Planning Commission Staff Report

Petition: **P.Z. 09-2022 Valley Village (Stock & Associates):** A request for a zoning map amendment from a “C8” Planned Commercial District to a “PC” Planned Commercial District for 10.9 acres located on the northwest corner of Chesterfield Airport Road & Wings of Hope Blvd (17W620312, 17W620334, 17W640091).

RE: PZ 09-2022 Valley Village – Response to Departmental Letter
(Stock Project No. 215-5542.8)

SHEET NO.:
C1.0

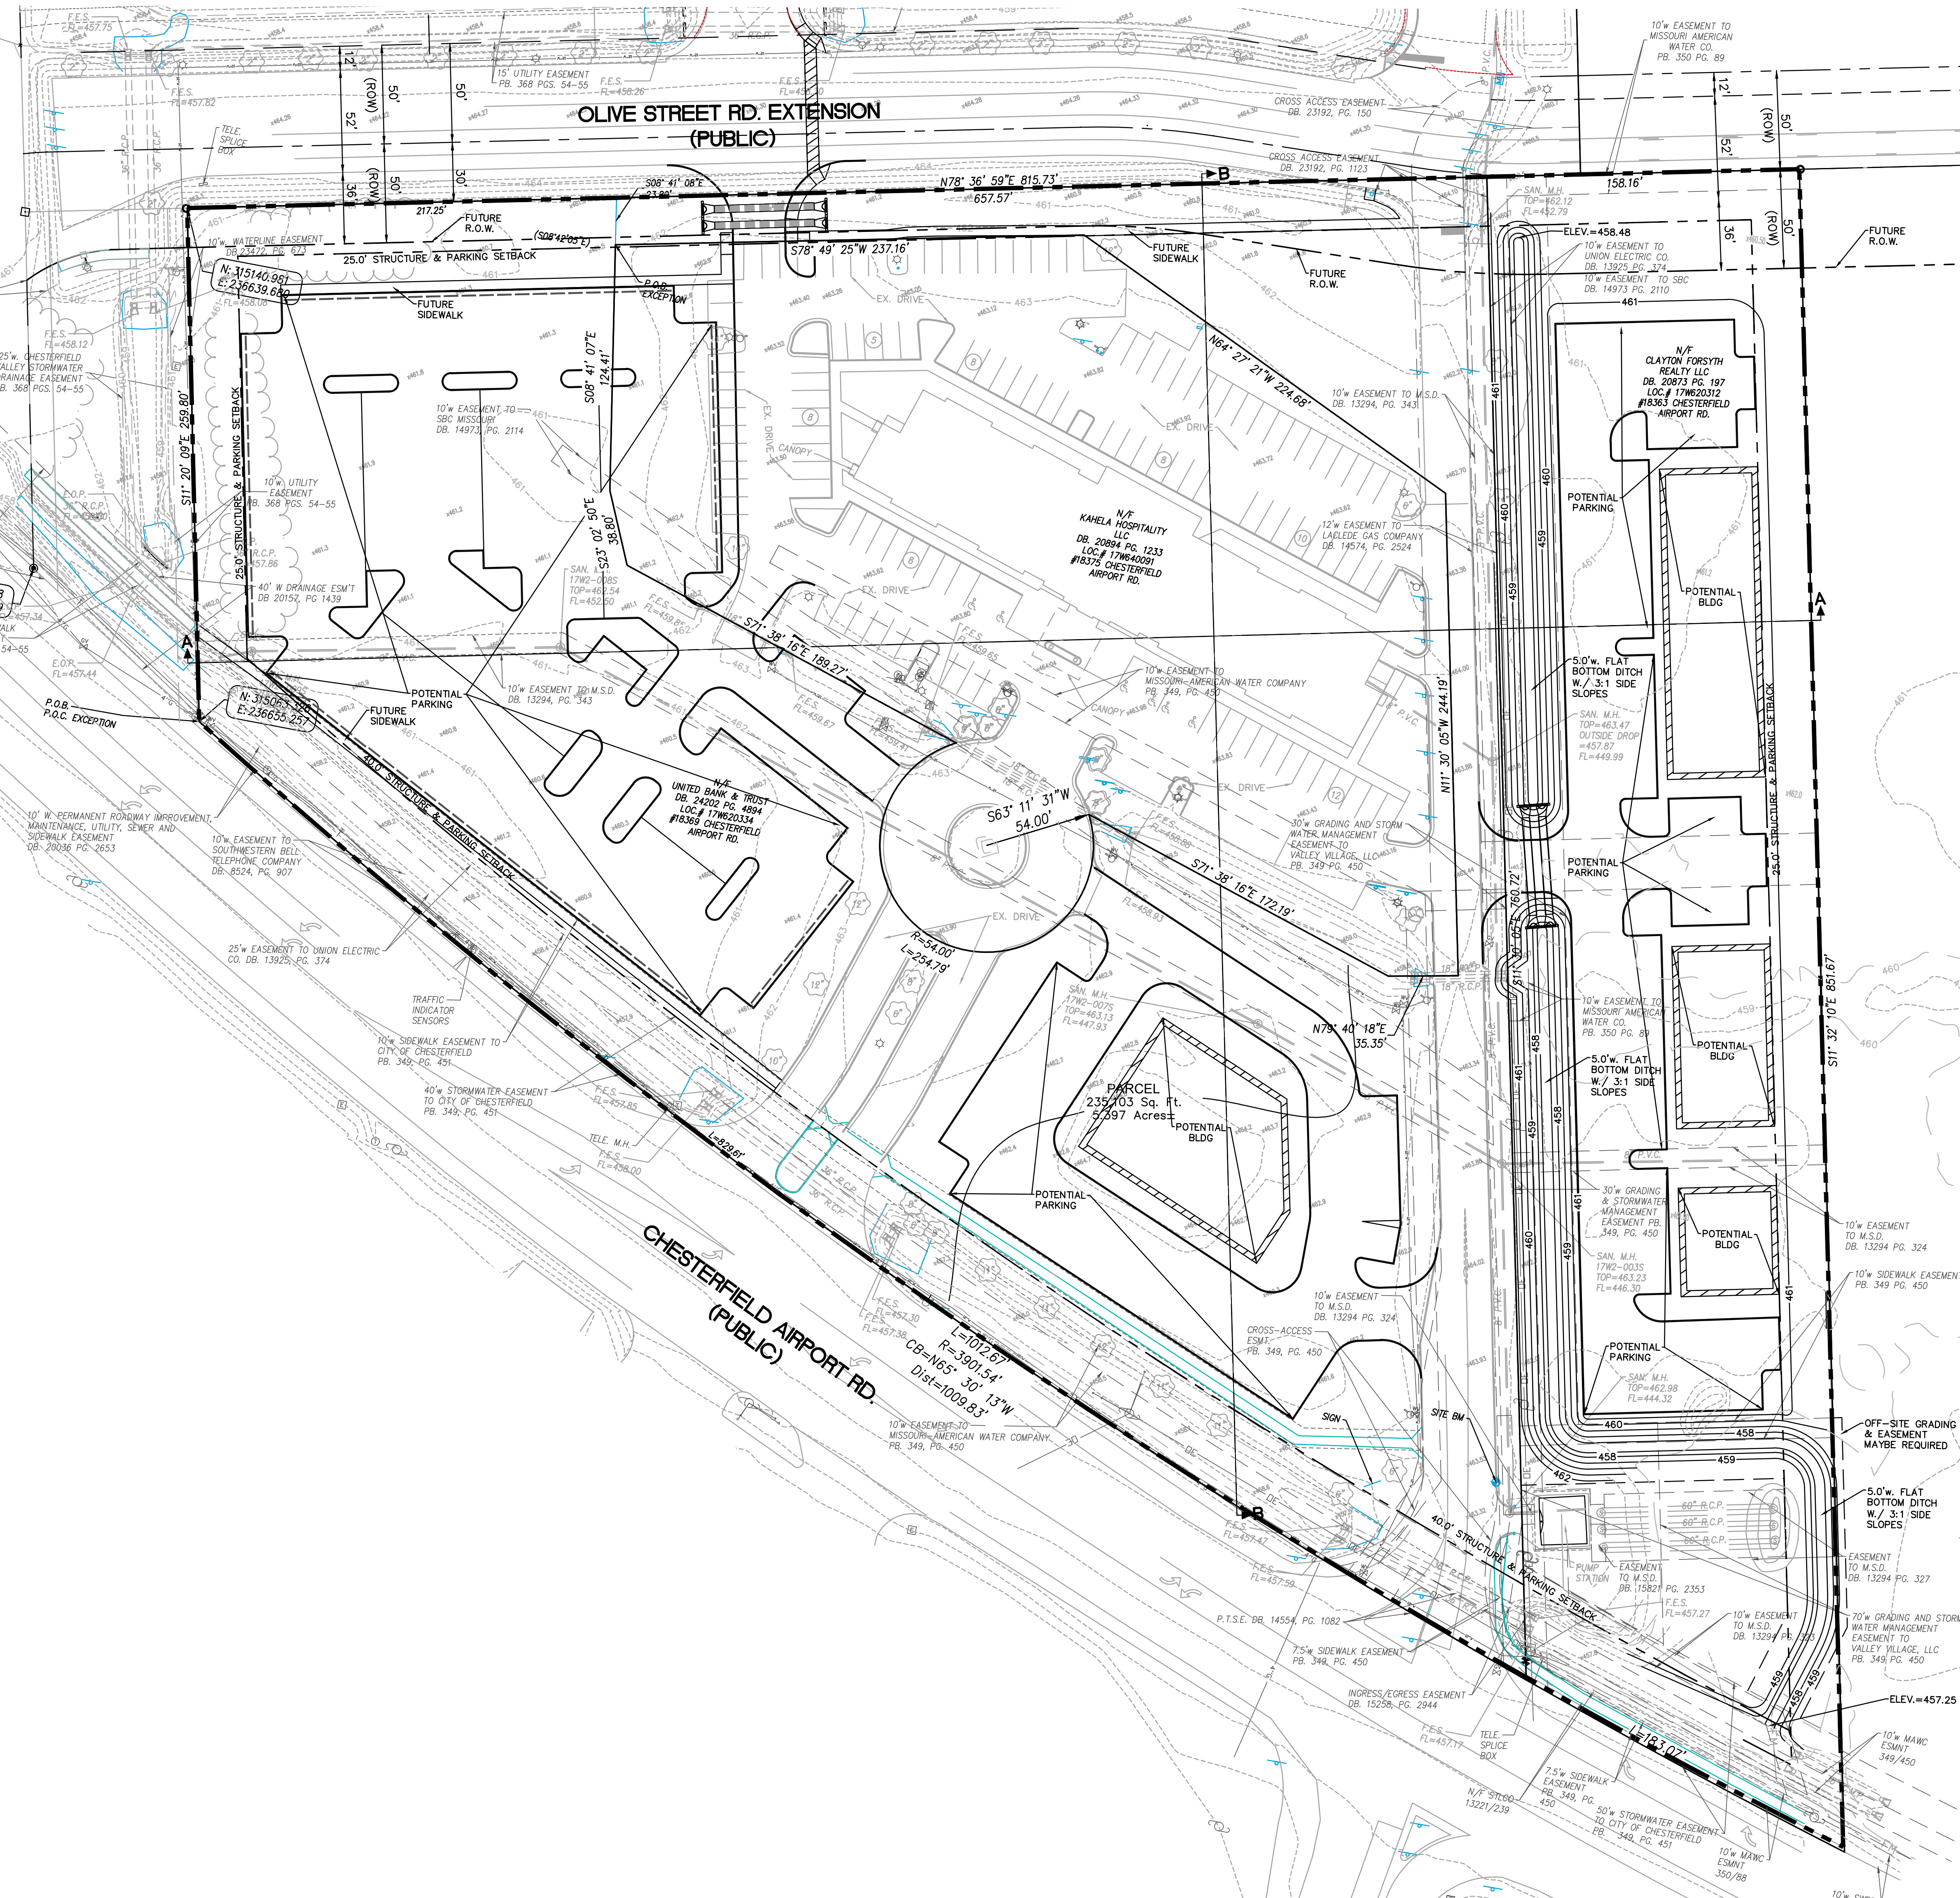
1. Show the property setbacks, parking setbacks, easements, and dedications in the plan.

2. Label the internal existing roadways.

4. Storm water culverts will be required under the access drive to the eastern portion of the site to accommodate the Master Plan Channel. Please show the culverts.

5. Add proposed sidewalk locations along Chesterfield Airport Road and Olive Street Road to the plan.

6. The southernmost proposed driveway on the west side of the internal access road may not meet the minimum corner clearance requirement from Chesterfield Airport Road. Please review City Code Section 405.04.100 (F) Figure A2 and adjust the driveway location to meet the minimum clearance requirement based on the corner radius from Chesterfield Airport Road to the internal access road. The minimum corner clearance is 120 feet from major arterials.

7. The proposed driveway to Olive Street Road may not meet the minimum driveway throat length of 80 feet for an arterial roadway. Please review.

8. Show/label the future ROW dedication for Olive Street Road.

Response: Added to the Plan.

Response: Added to the Plan.

Response: Added to the Plan.

Response: Added to the Plan.

Response: Southernmost proposed driveway has been shifted north to meet the City's access management clearance requirements.

Response: The maximum throat depth we are able to achieve is 59.0' feet. An 80.0' throat would conflict with the existing hotel parking and drive aisle.

Response: Added to the Plan.

SECTION A - A VALLEY VILLAGE PROFILE

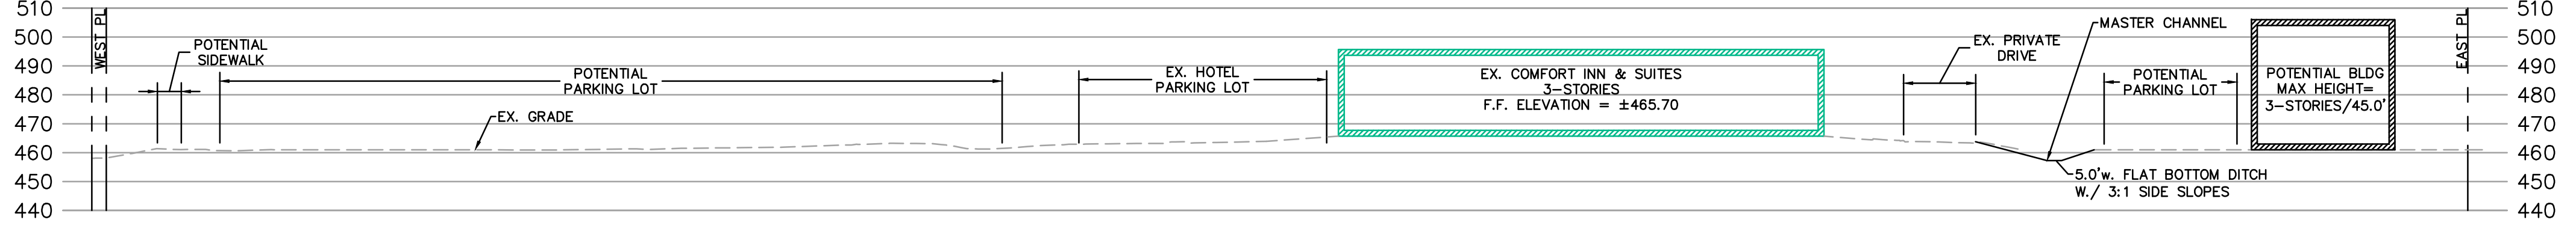
3. A 5' wide flat bottom ditch with 3H:1V side slopes is required east of the existing private drive (see attached excerpt from the Chesterfield Valley Storm Water Master Plan). Please show the future channel area on the plan and update Section A-A to reflect channel location as well.

Response: Added to the Plan.
